### APPEAL SUMMARY

<b>Appeal ID:</b> 20494	<b>Project Address:</b> 1332 N Skidmore St
<b>Hearing Date:</b> 6/12/19	<b>Appellant Name:</b> Nicolette Stauffer
<b>Case No.:</b> B-006	<b>Appellant Phone:</b> 503-233-9856
<b>Appeal Type:</b> Building	<b>Plans Examiner/Inspector:</b> Maureen McCafferty
<b>Project Type:</b> commercial	<b>Stories:</b> 6 <b>Occupancy:</b> R-2, S-2, A-3 <b>Construction Type:</b> I-A, III-A
<b>Building/Business Name:</b> Overlook/Skidmore Apartments	<b>Fire Sprinklers:</b> Yes - Throughout
<b>Appeal Involves:</b> Erection of a new structure	<b>LUR or Permit Application No.:</b> 17-187378-CO, 17-187384-CO
<b>Plan Submitted Option:</b> pdf [File 1] [File 2]	<b>Proposed use:</b> Mixed-Use

## APPEAL DECISION

title:  
SKIDMORE/OVERLOOK  
EXHIBIT 2  
TYPICAL STUDIO LOFT  
RCP

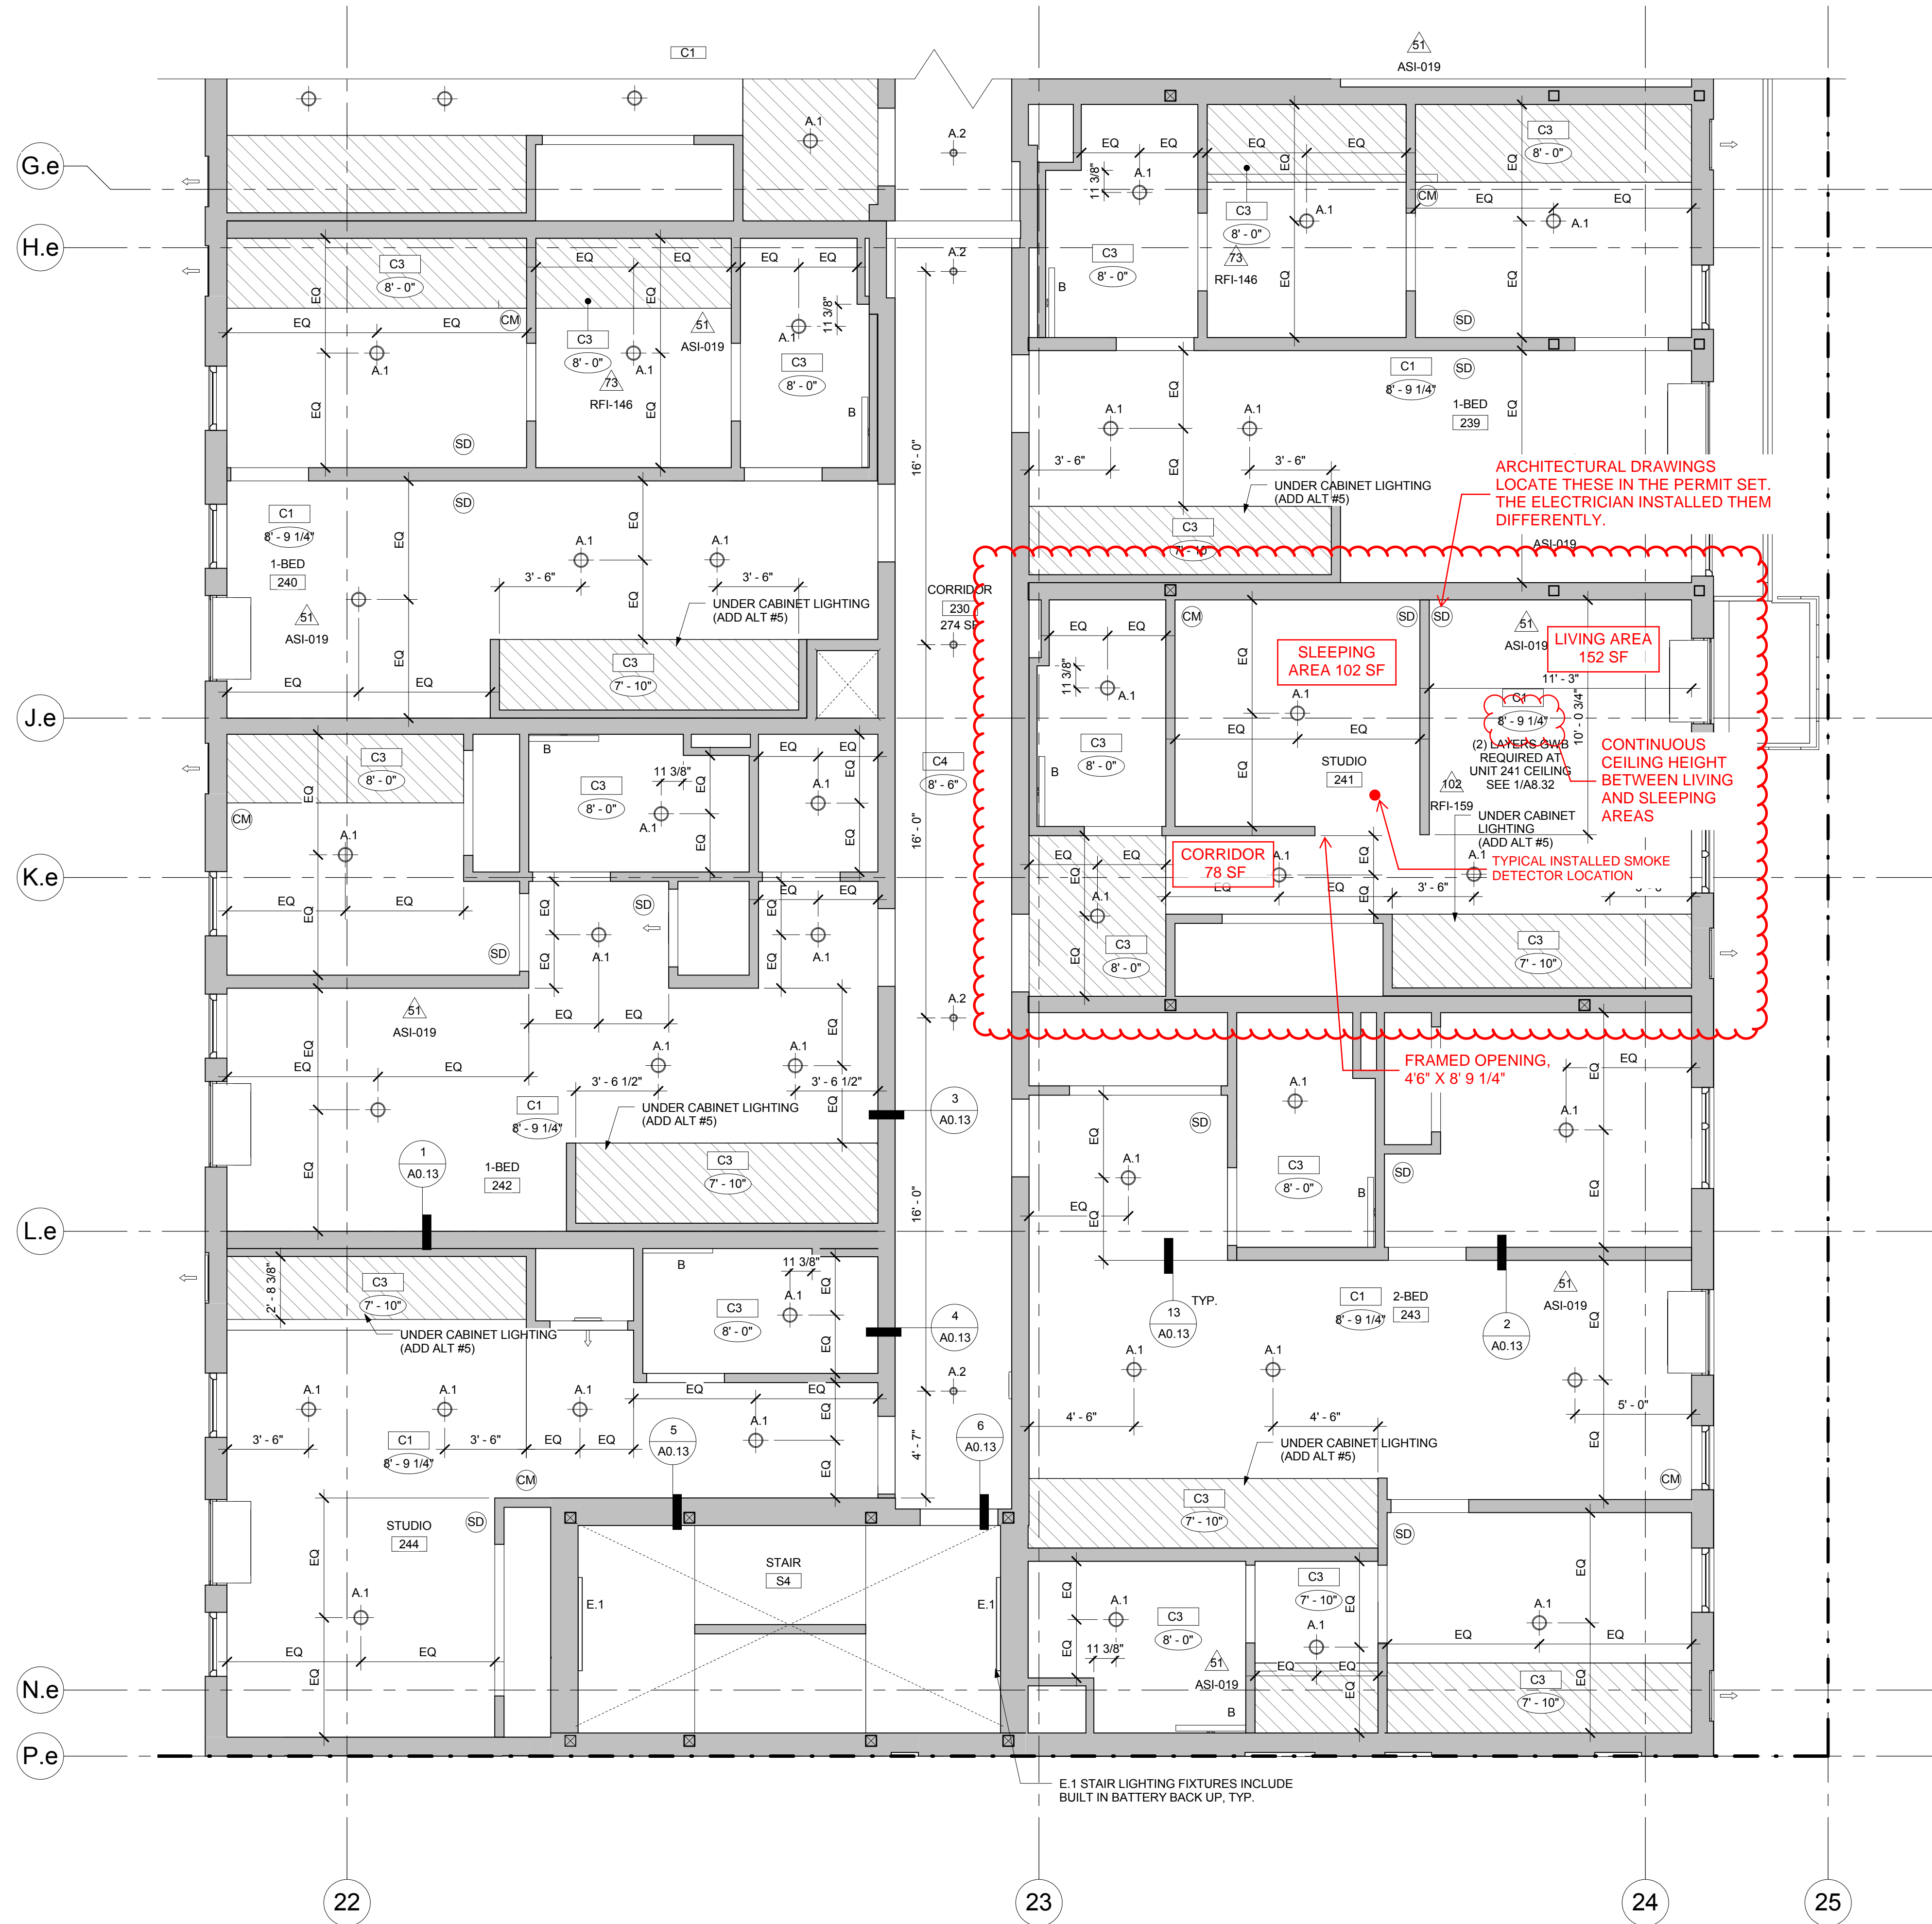
do not include a separate closed-off sleeping room. As a result, a single smoke alarm is currently placed on the ceiling just inside the sleeping area, adjacent to the living area. Please refer to Exhibit 1 for a Studio Loft reflected ceiling plan and Exhibit 2 for an annotated photograph of the current field conditions.

**Reason for alternative** The proposed design and current field conditions do not make separate enclosed spaces which would trigger multiple smoke alarms. The single smoke alarm meets the intent of the code requirement by providing a device which can detect smoke emanating from the connected spaces since there are no restrictions at the ceiling plane. This differs from other unit types in the building, such as a One Bedroom unit which does have an enclosed sleeping space and therefore a separate smoke alarm.

**Omission of smoke alarm in room used for sleeping purposes: Granted provided no door, bulkhead or curtain is installed between the sleeping area and the corridor and the adjacent space.**
